Re: Review letter for West Magnolia (FKA East Sunnyside) PRD/BSP (PA22-033)

City of Marysville Community Development – Planning Division

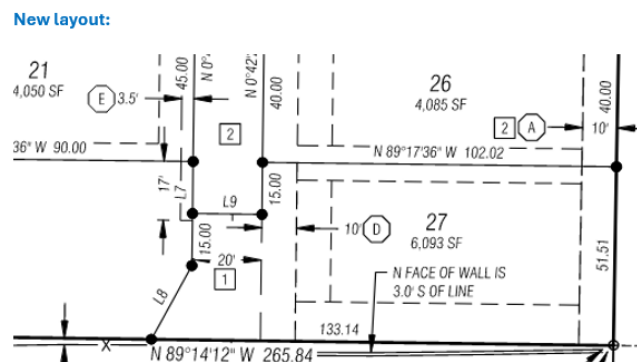
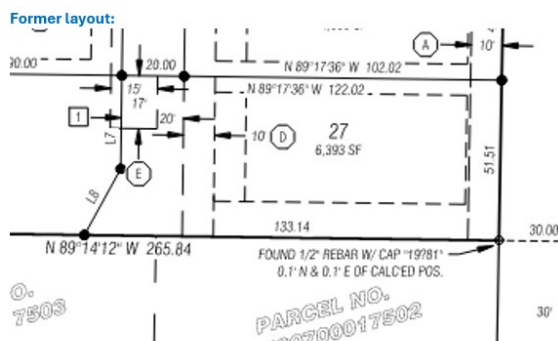
32. Sheet 4, distances along Road A right of way are missing.

Added.
